Index 700-091 Catwalk Detail

COMMENTARY

COMMENTS AND RESPONSES

GENERAL ASSEMBLY

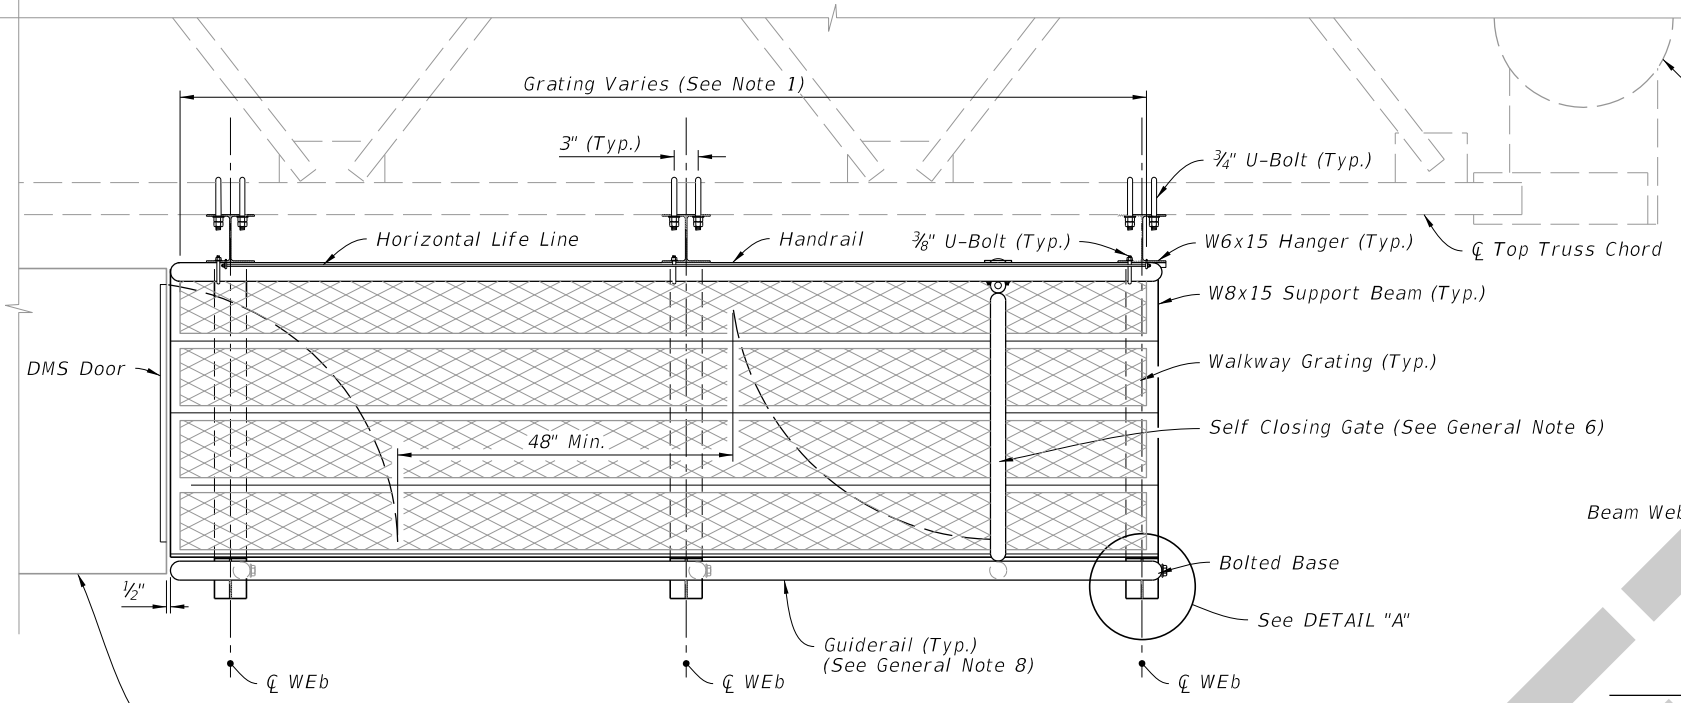
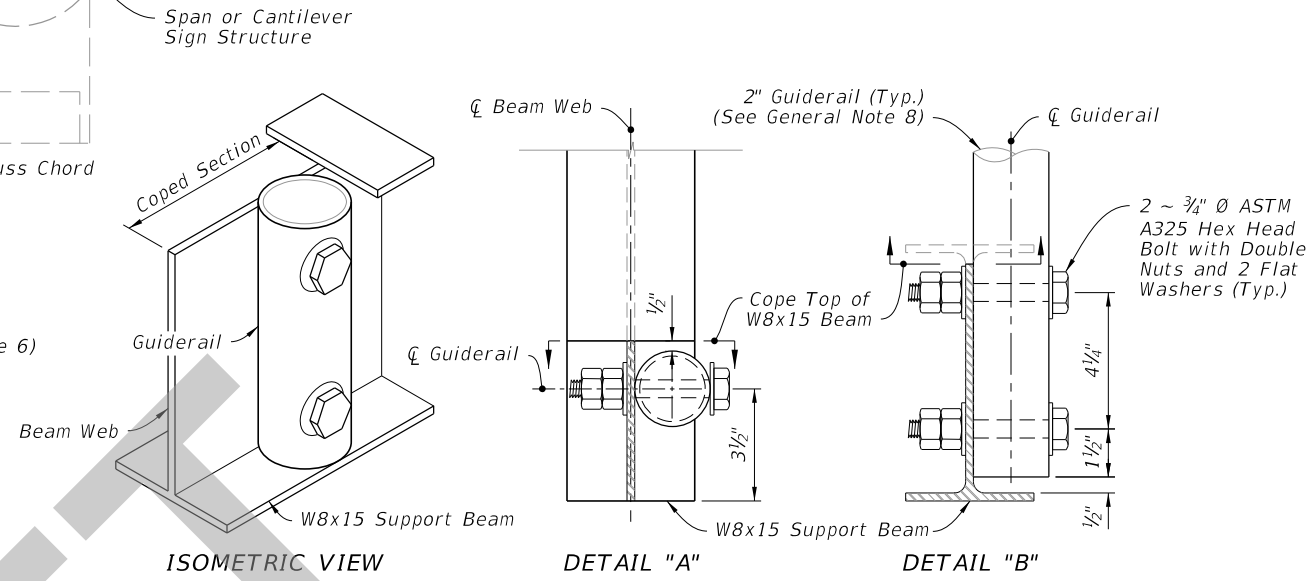
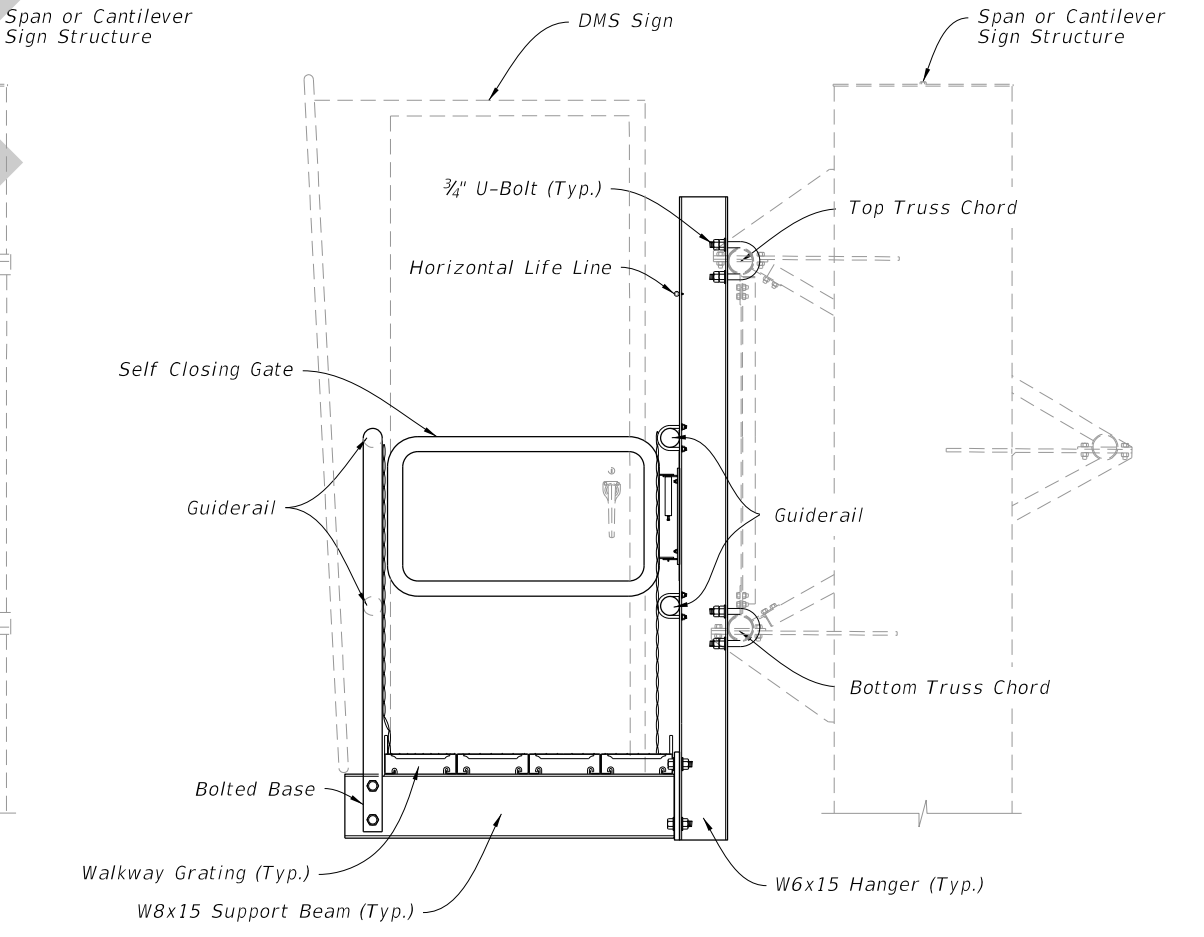
Sheet 2 & 3 – Update design to improve safety:

1. Add chain link infill panels between the guiderails
2. Change the W6x15 walkway support to W8x15
3. Add horizontal life line
4. Added self-closing safety gate
5. Increased guiderail size
6. Changed the Fixed Base guiderail to a Bolted Base guiderail
7. Increased U-bolt and Bolted Base bolts to ¾"
8. Removed Gusset Plate to reduce the gap between the guiderails and walkway

Made all changes.

FRONT ELEVATION

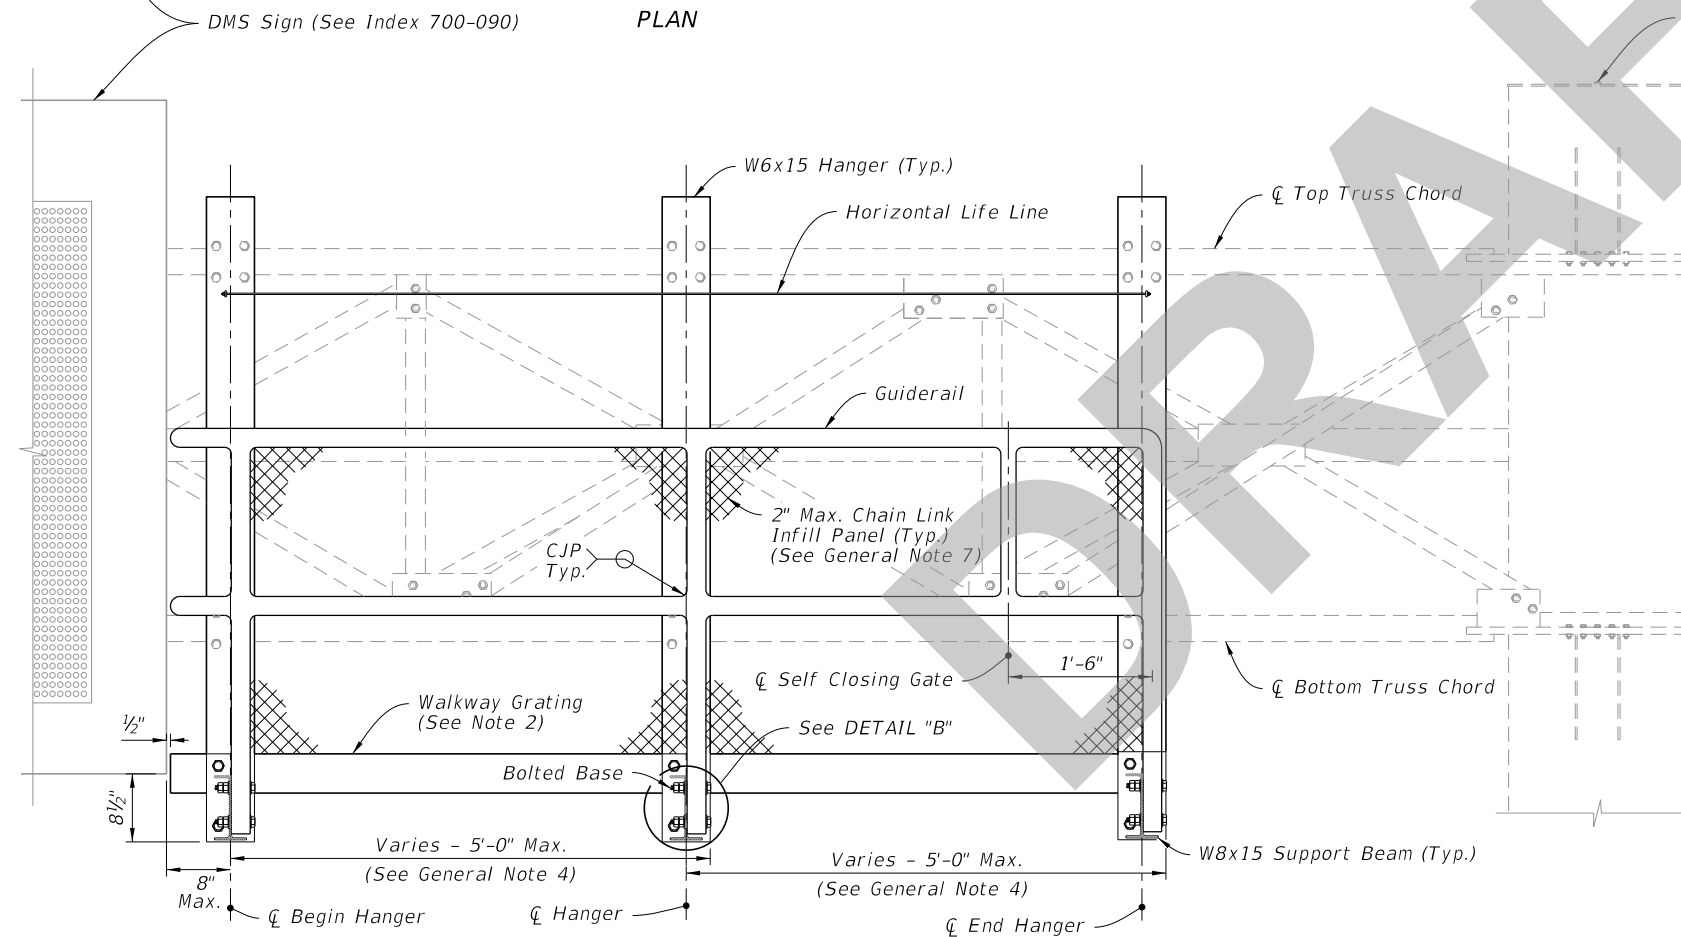
1. Catwalk details should have a typical section showing the distance it should be placed behind the guardrail and shoulder. The index only includes an isometric view without any dimensions behind the guardrail.
2. Recommend adding a dimension line from the guardrail to the upright and clarify that minimum offset criteria should be met to the upright if the foundation is flushed. If the foundation is sticking out of the ground, the offset criteria would need to be met up to the foundation.
3. Detail should also provide space to park a bucket truck behind the guardrail. This shows no future allowance for maintenance access.

1. Covered in General Note 5 and shown in the FRONT ELEVATION detail on Sheet 2.
2. Guardrail and Structure (including foundation) are covered in their indexes and are noted on Sheet 1. They are grayed and dashed shown as prospective.
3. This should be covered in the Plans, not in the Catwalk Detail. The goal of the index is to show how the Catwalk attaches to the Truss System and in reference to the Dynamic Message Sign and the outer edge of the Pave Shoulder.
